U.S. Department of the Interior
BUREAU OF LAND MANAGEMENT

Sundry Print Report

Well Name: Fuller 14/23 W1KN	Well Location: T26S / R29E / SEC 14 / NWSE /	County or Parish/State:
Well Number: 3H	Type of Well: CONVENTIONAL GAS WELL	Allottee or Tribe Name:
Lease Number: NMNM11038	Unit or CA Name:	Unit or CA Number:
US Well Number: 3001549318	Well Status: Approved Application for Permit to Drill	Operator: MEWBOURNE OIL COMPANY

Notice of Intent

Planning Report

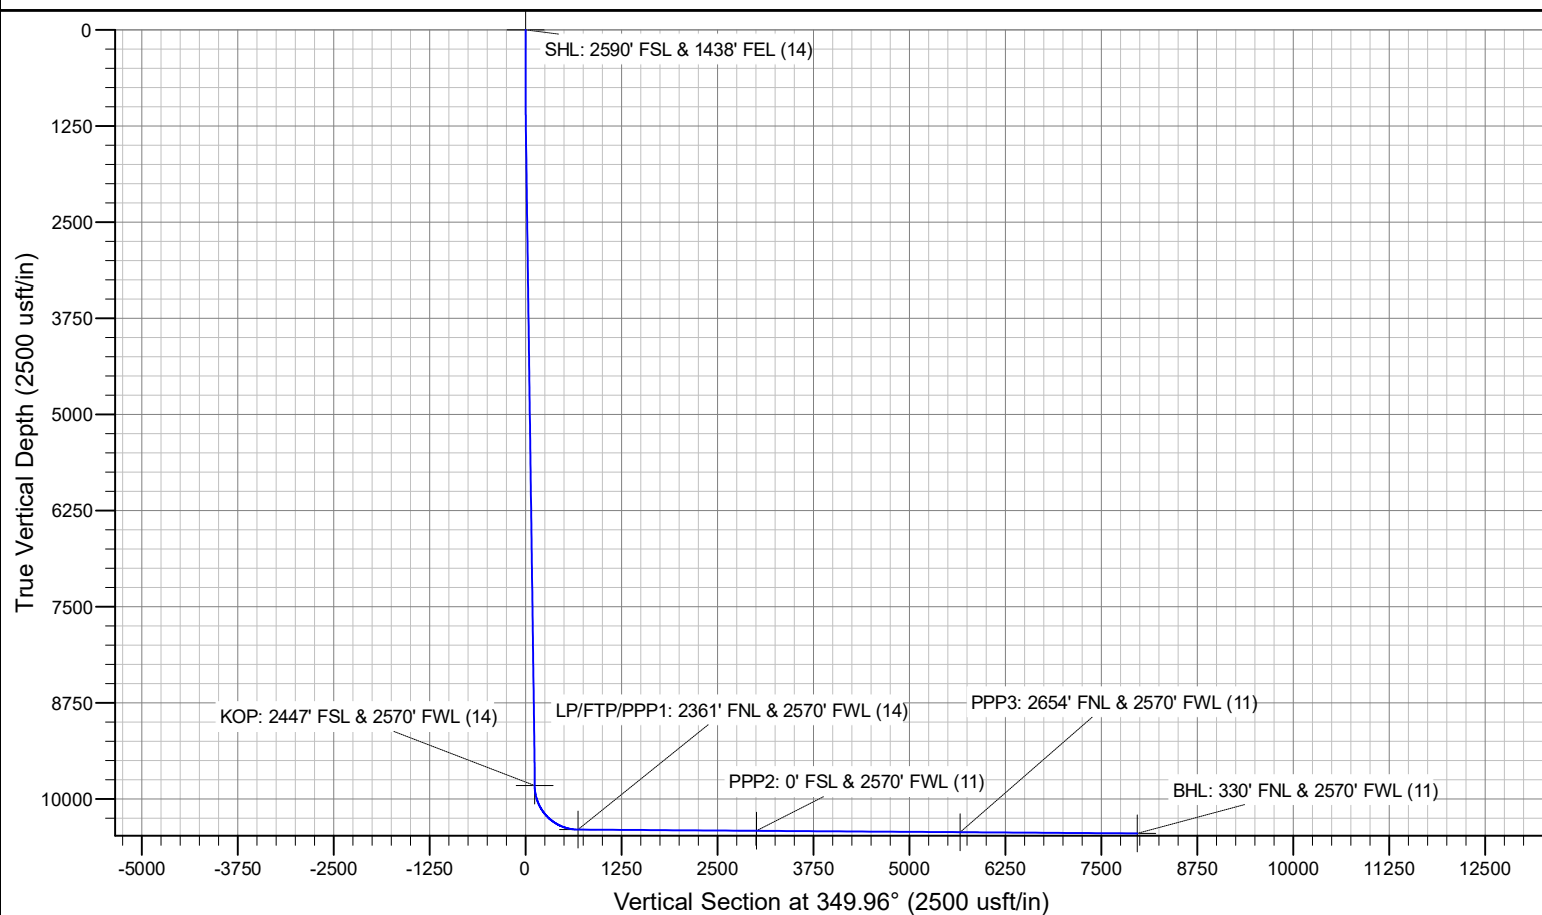
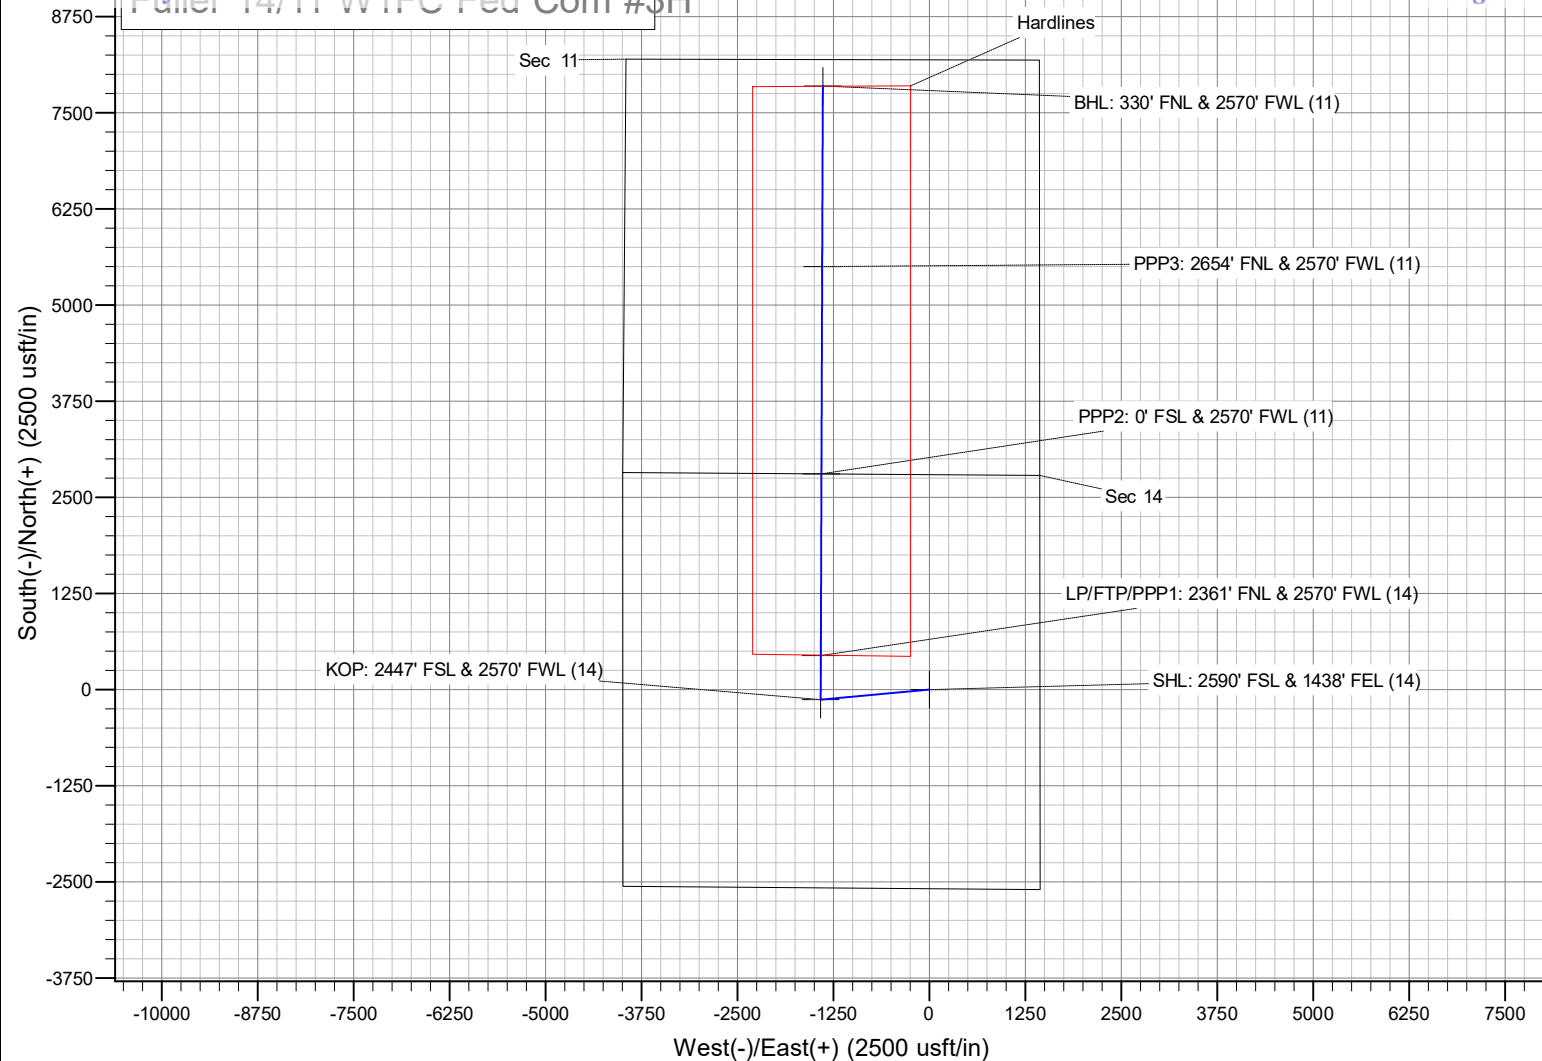
1. Well name change to Fuller 14/11 W1FC Fed Com #3H.
2. BHL change to 330' FNL & 2570' FWL in Sec 11, T26S, R29E
3. Changes to directional design plot & plan corresponding to BHL change are included in sundry attachments.
4. Changes to csg program & cmt program corresponding to BHL change are included in this sundry request on page 3 & 4.
